May 29, 2018
IDEA PUBLIC SCHOOLS – IDEA Brownsville Robindale Phase I

ADDENDUM NO. 2

A. PURPOSE AND INTENT
This addendum is issued for the purpose of modifying the plans and specifications for the IDEA PUBLIC SCHOOLS – IDEA Brownsville Robindale Phase I

Date: May 11, 2018
Scale: As Noted
Project Architect: David Monreal, AIA
Drawn By: JA, RB
Job No. IDEA Robindale Phase I
Sheet: A2.07

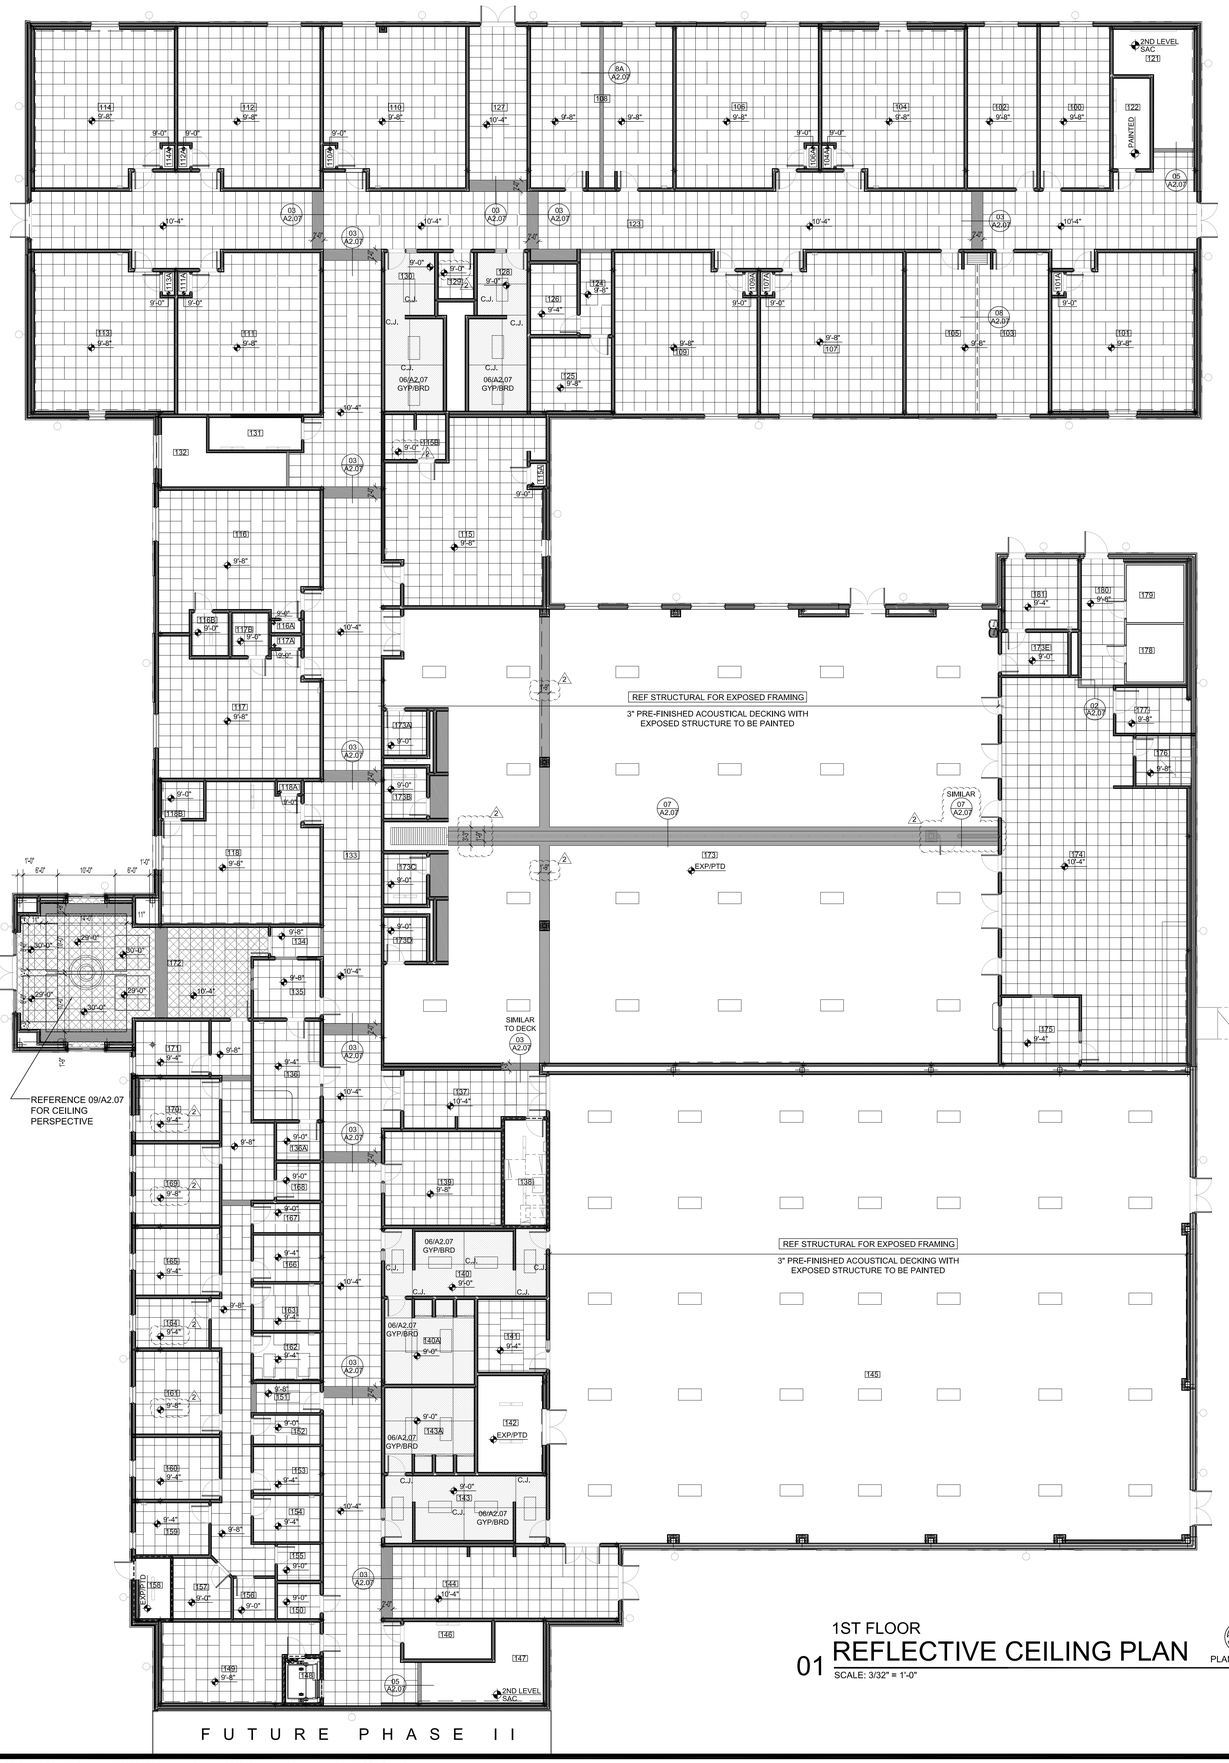
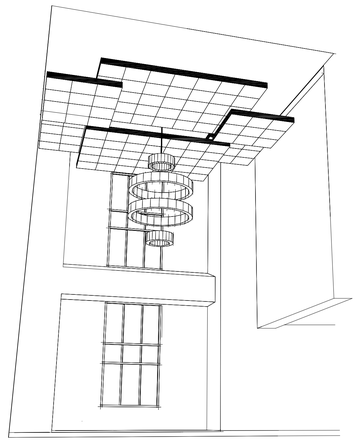
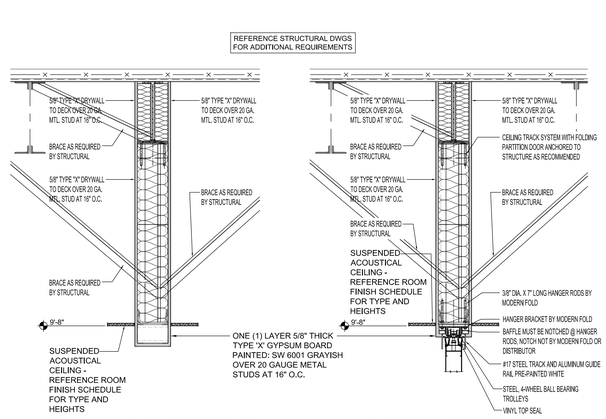
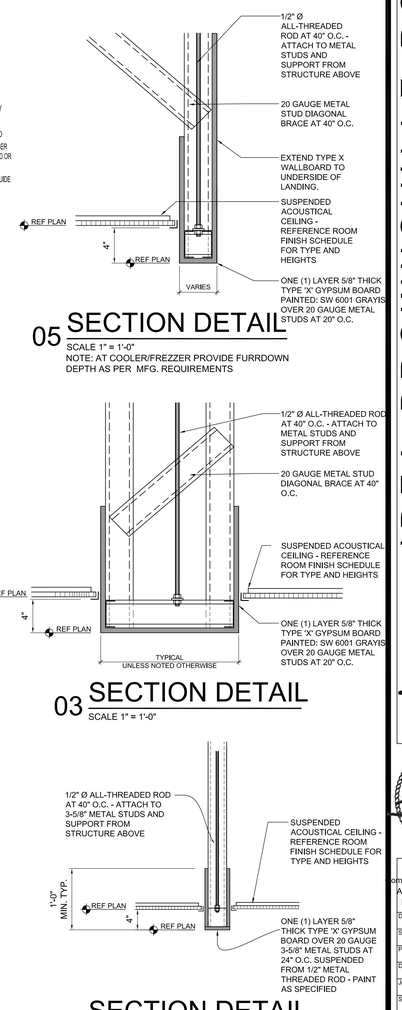
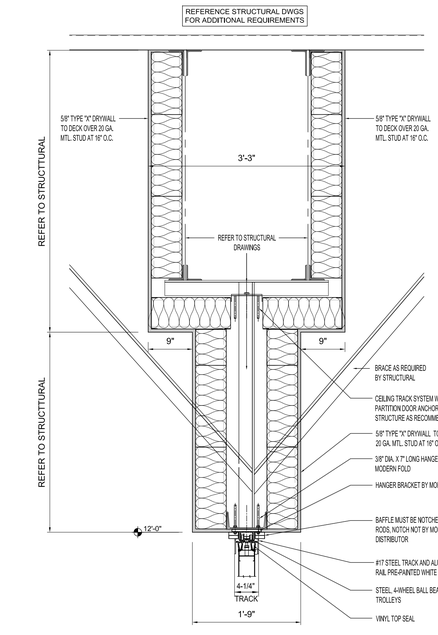
8. Sheet A2.07 – First Floor Reflected Ceiling Plan
    a. REVISE Section Keys and Detail References at folding partition furr down – Replace Sheet A2.07 previously issued with Sheet A2.07 included in this addendum.

Date:	May 11, 2018
Scale:	As Noted
Project Architect:	David Monreal, AIA
Drawn By:	JA, RB
Job No.	IDEA Robindale Phase I
Sheet:	A2.12

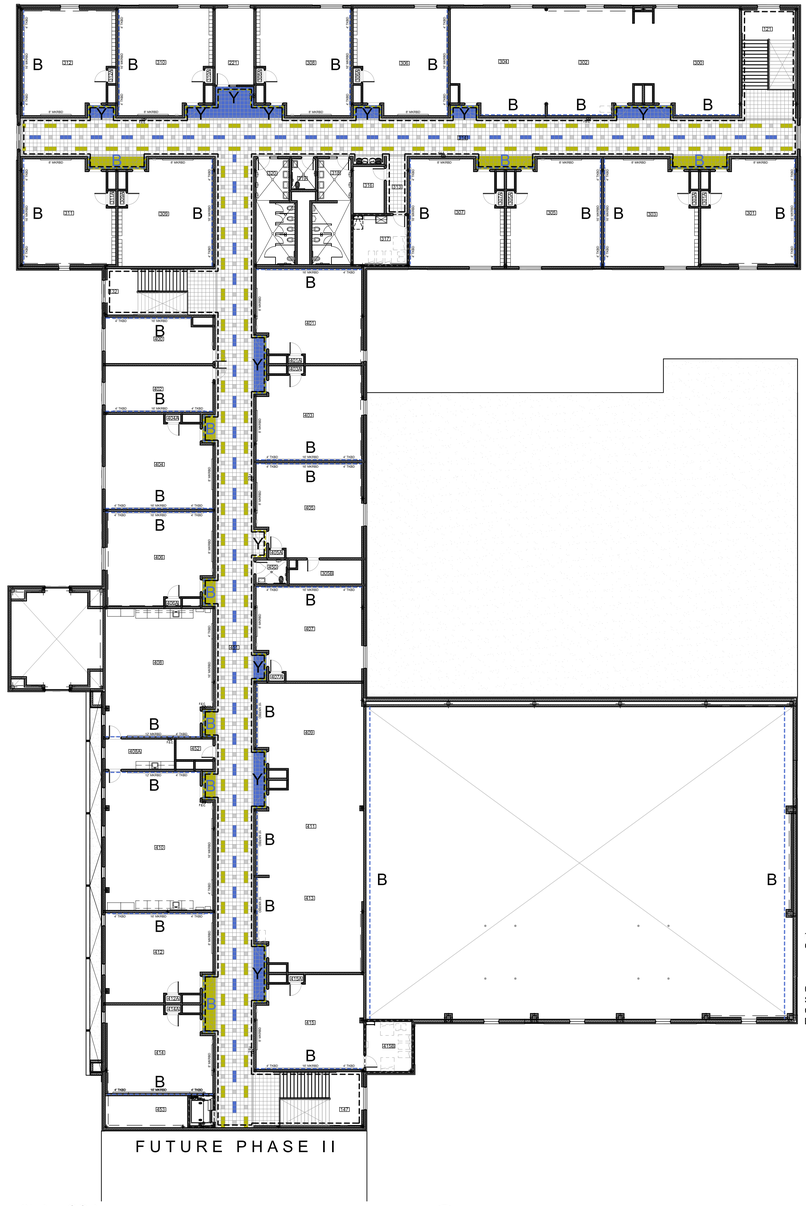
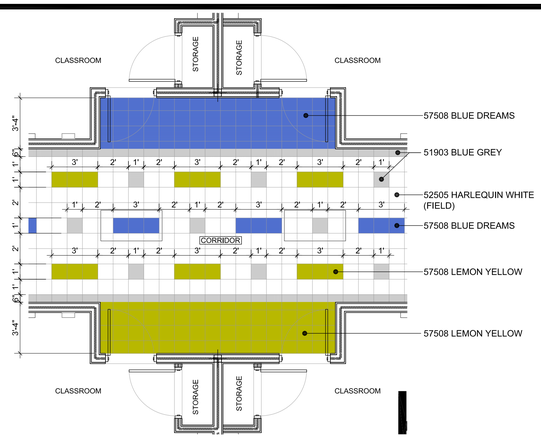
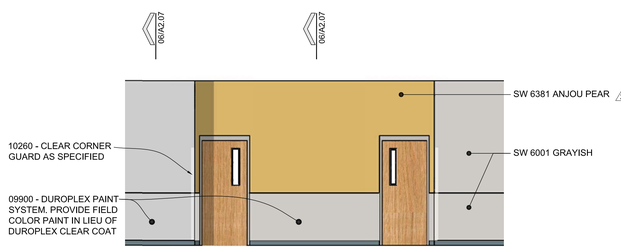
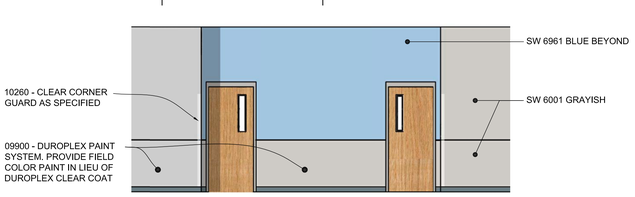
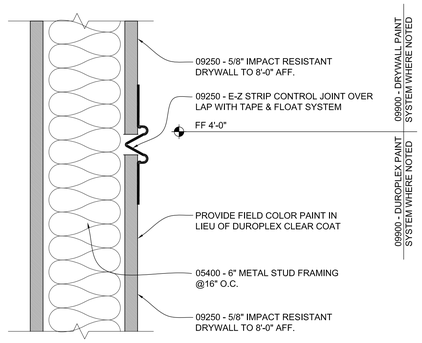
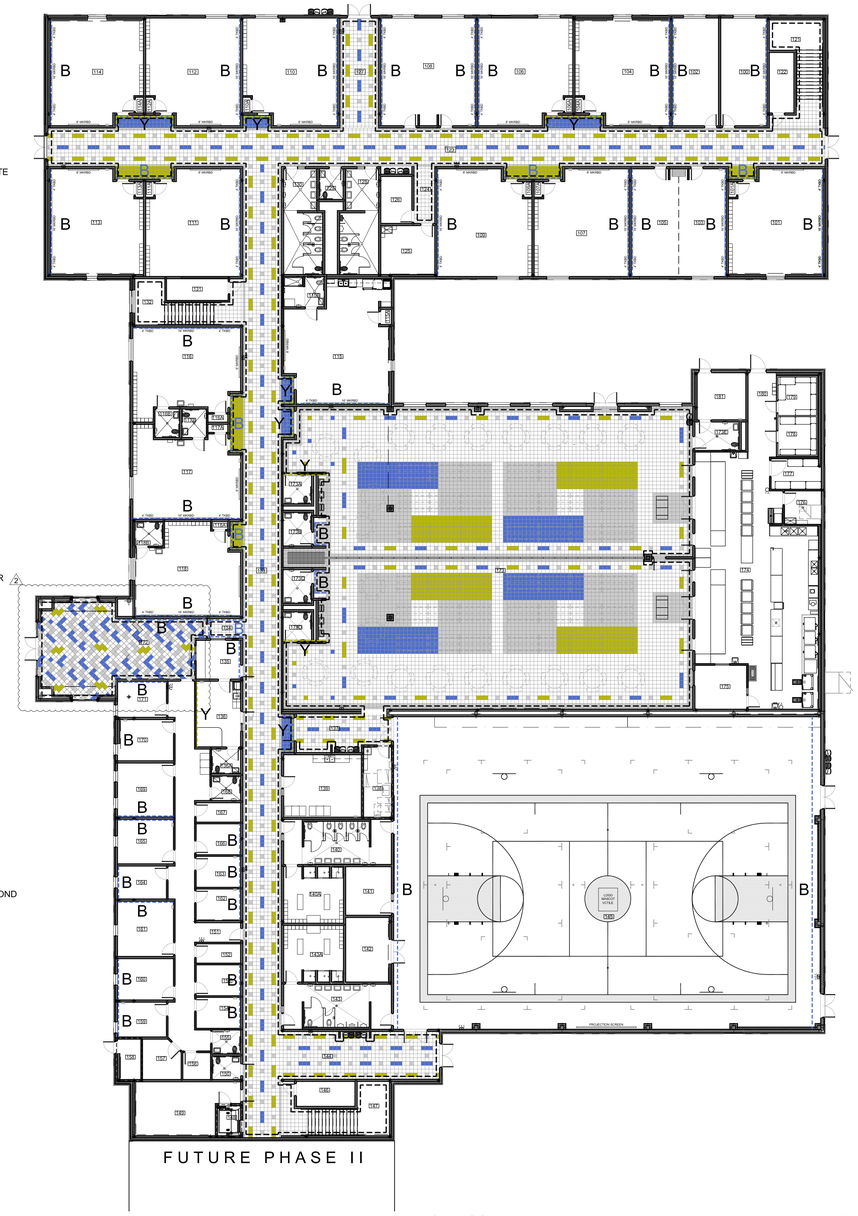
9. Sheet A2.12 – VCT Pattern and Accent Wall Locations Plan
    a. ADD VCT Tile Pattern to Main Entry and Lobby – Replace Sheet A2.12 previously issued with Sheet A2.12 included in this addendum.

Date:	May 10, 2018
Scale:	As Noted
Project Architect:	David Monreal, AIA
Drawn By:	ETHOS
Job No.	IDEA Robindale Phase I
Sheet:	M3.04

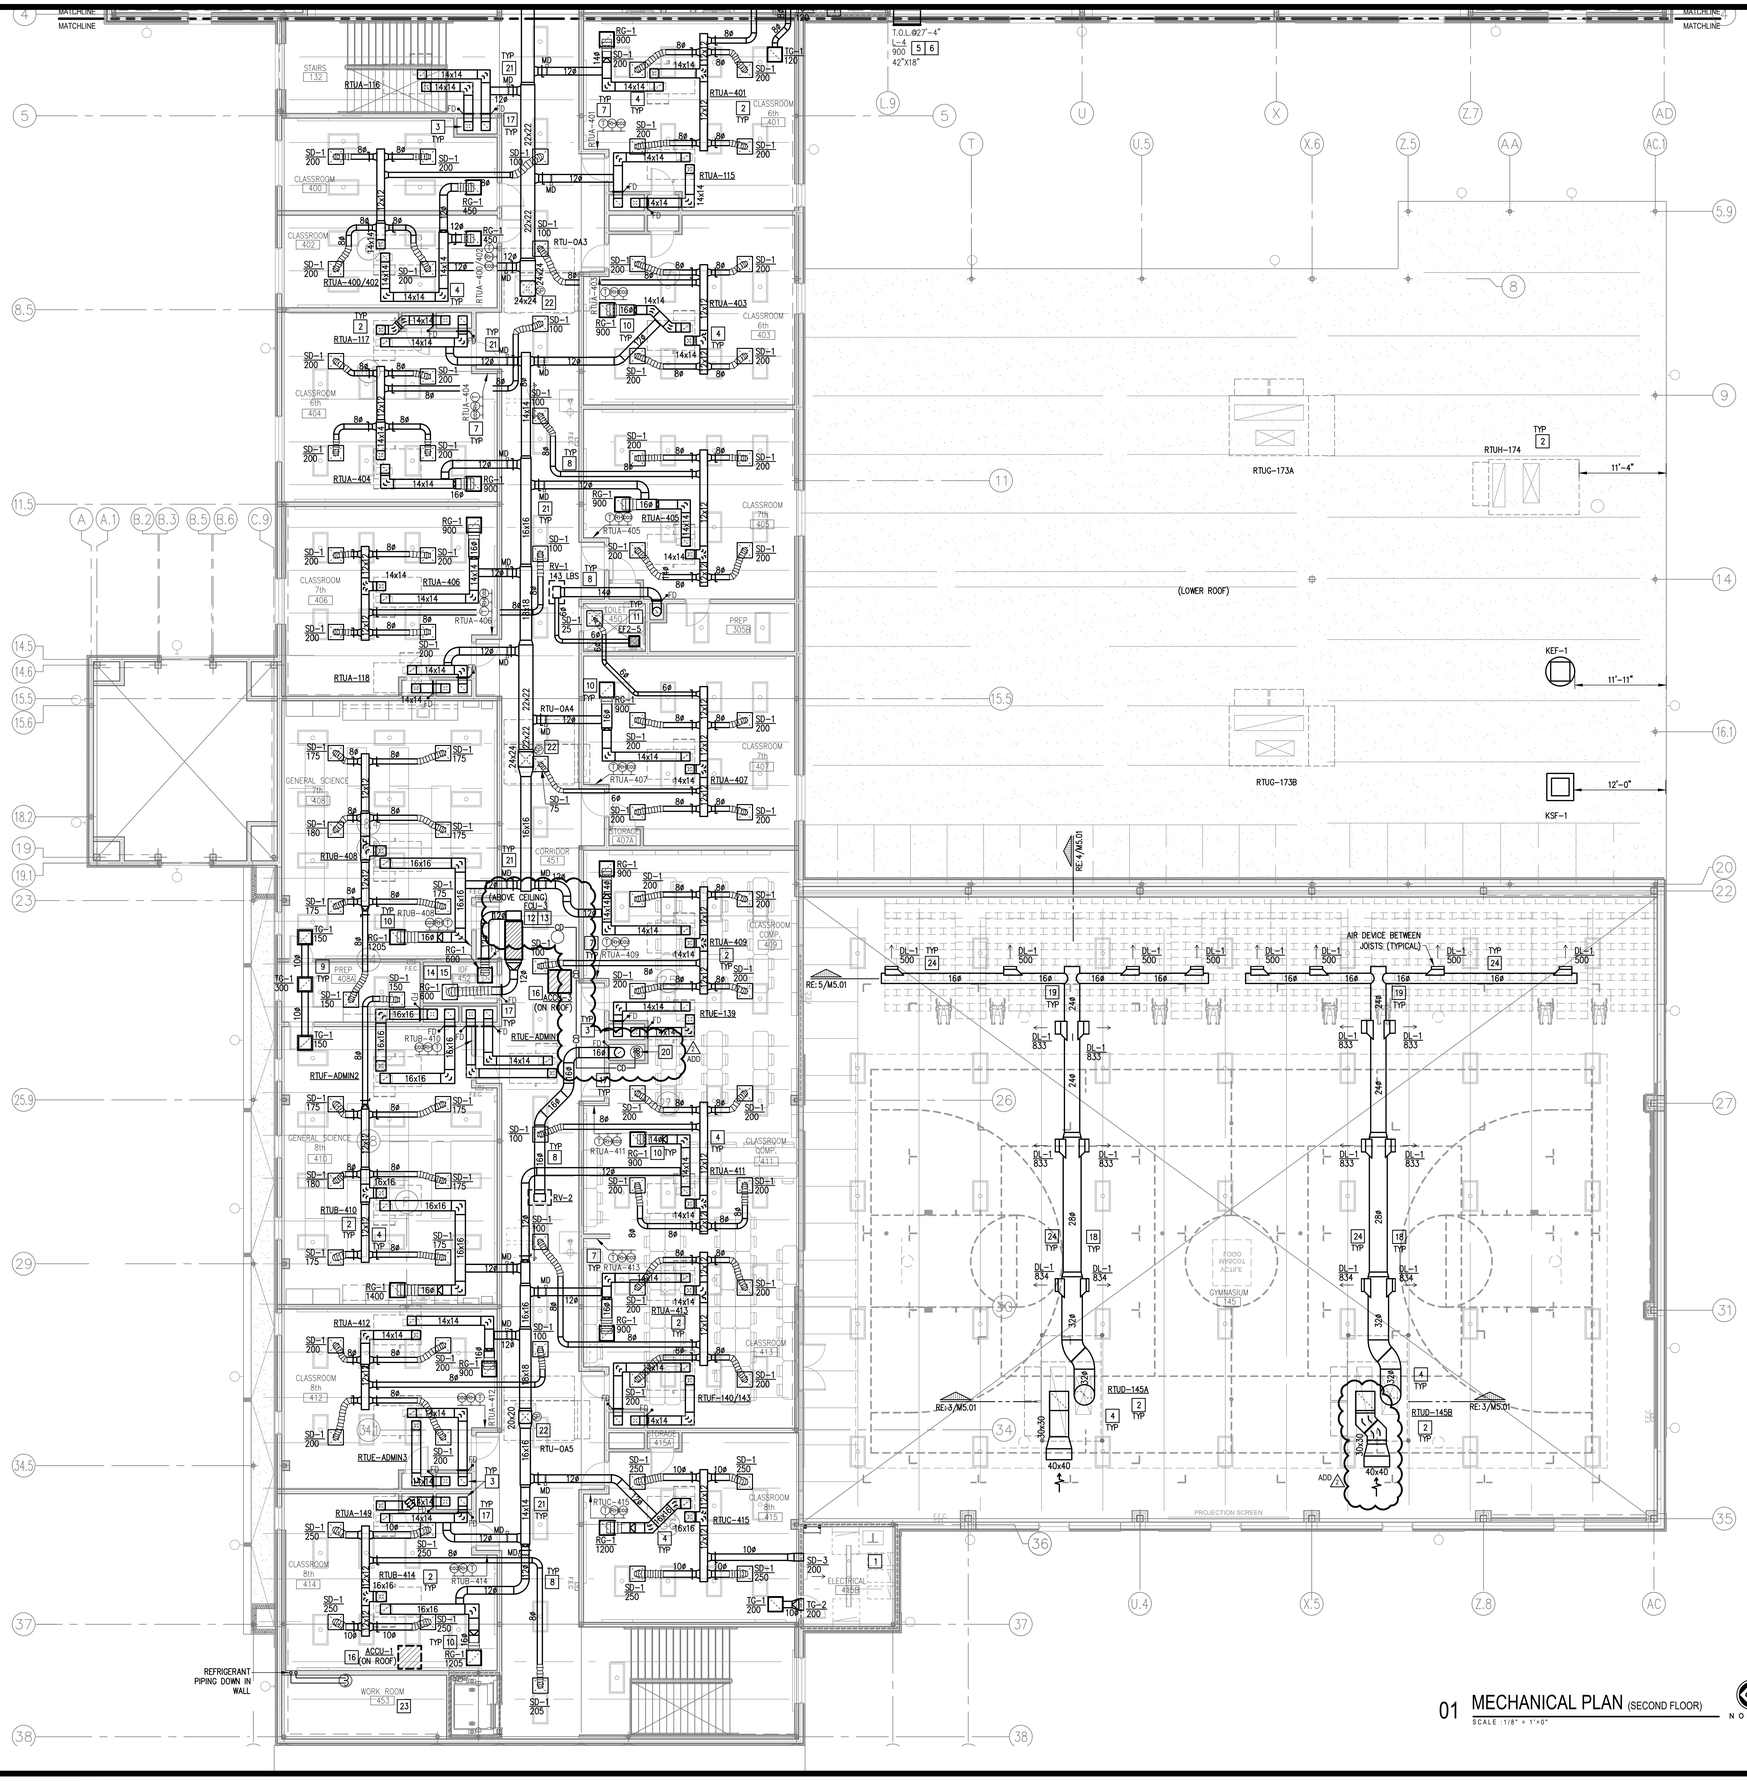
2) Sheet M3.04:
    a) Revised Second Floor Mechanical Plan (Gym ductwork – Modification). See attached sheet.
